**SUBDIVISION COMMITTEE
METROPOLITAN AREA PLANNING COMMISSION**

**STAFF REPORT
(Preliminary Plat)**

CASE NUMBER: S/D 94-36 ROBBINS FARM 4TH ADDITION

STAFF REPORT
(Final Plat, Preliminary Plat Approved 5/26/94)

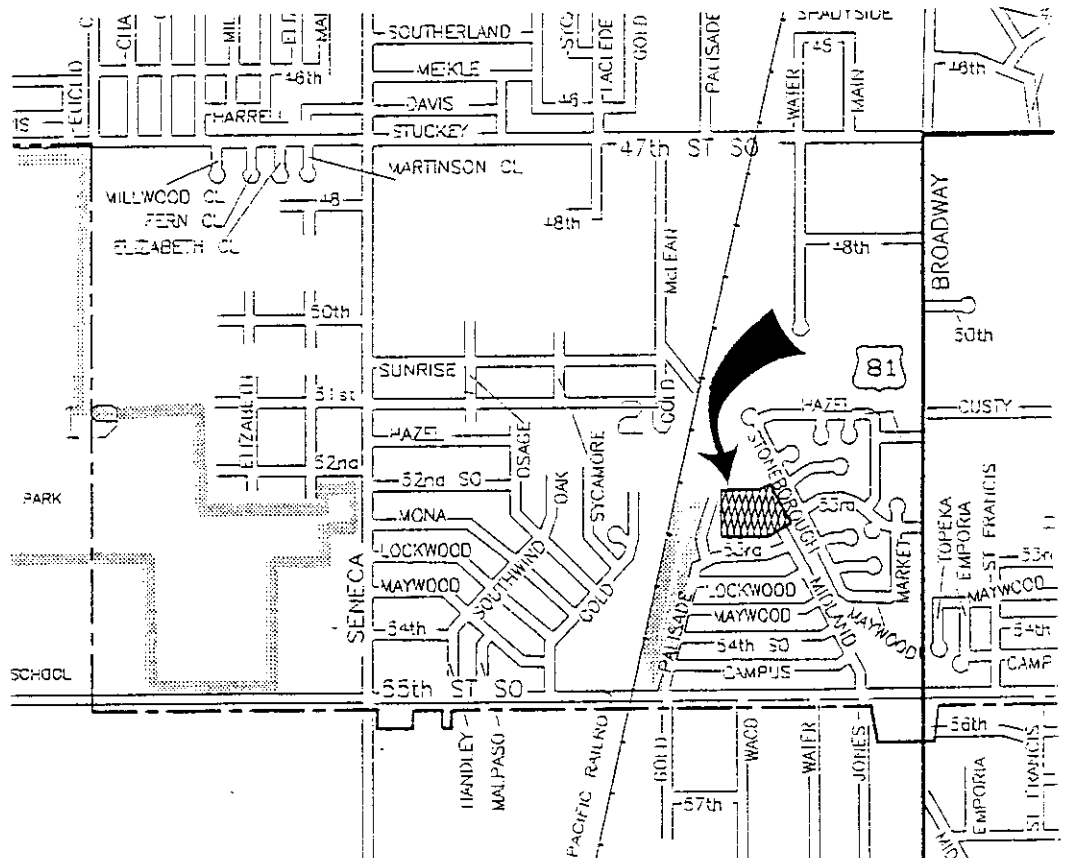
- A. The final plats shall be redesigned to continue Midland Street along the site's entire east line. Lots along the Court shall accordingly be redesigned to allow for this additional street dedication of Midland.

- G. Based on the previous Robbins Farms plats to the south of this site, the drainage area along the east side of this Addition should be shown as an exception, under City ownership. This area was condemned by the City and needs to be appropriately indicated as such by this plat.

- H. The applicant shall submit a covenant which provides for four (4) off-street parking spaces per dwelling unit on each lot which abuts a 58-foot street. The covenant shall inventory the affected lots by lot and block number and shall state that the covenant runs with the land and is binding on future owners and assigns.

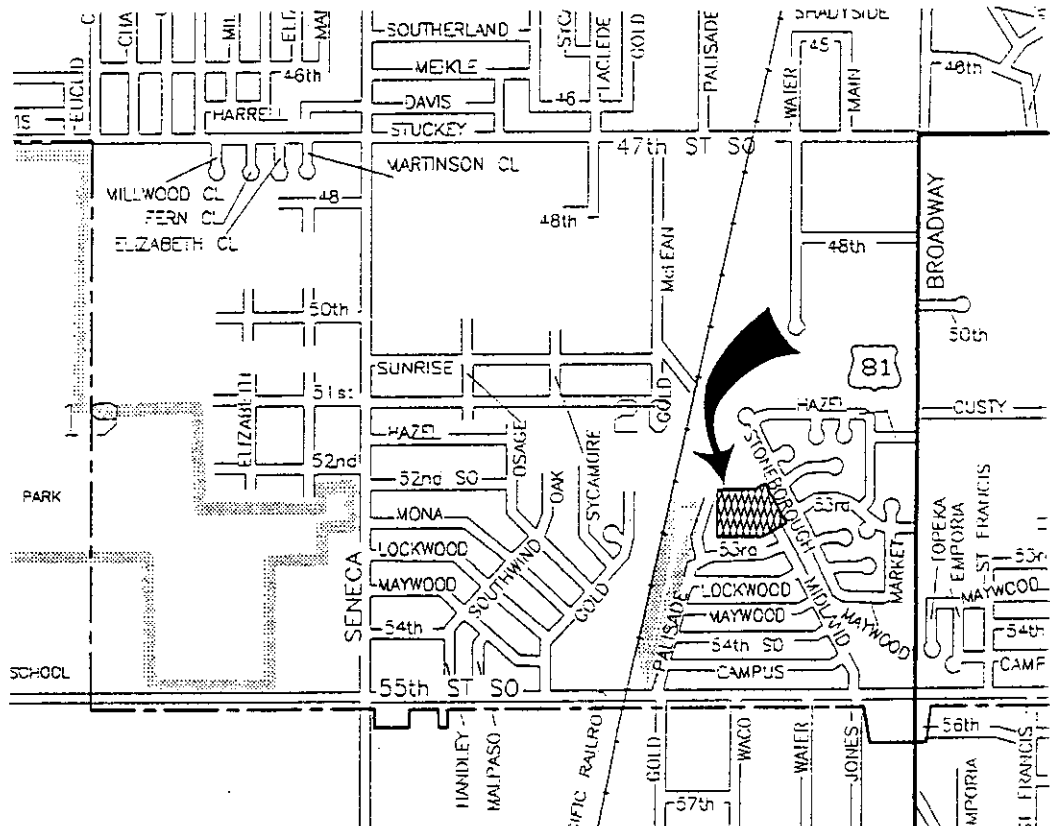
- F. Since this plat will result in Midland (street) being terminated by a cul-de-sac, the street name on the final plat tracing should be indicated as Midland Circle rather than as a Court. Also this street's terminus at the south line of this Addition should be shown with a dashed line rather than a solid line. Also, the utility easement need not be shown as crossing this street.

- G. The applicant shall submit a covenant which provides for four (4) off-street parking spaces per dwelling unit on each lot which abuts a 58-foot street. The covenant shall inventory the affected lots by lot and block number and shall state that the covenant runs with the land and is binding on future owners and assigns.

- K. Perimeter closure computations shall be submitted with the final plat tracing. Section 5-101(c).

- L. Recording of the plat within 30 days after approval by the City Council.
- M. The representatives from City Engineering should be prepared to comment on the status of the applicant's drainage plan. Also, Engineering needs to indicate if the minimum opening pad elevations are acceptable.
- N. Both City Engineering and the utilities need to indicate if additional easements, either on-site or off-site are needed along the plat's north line.
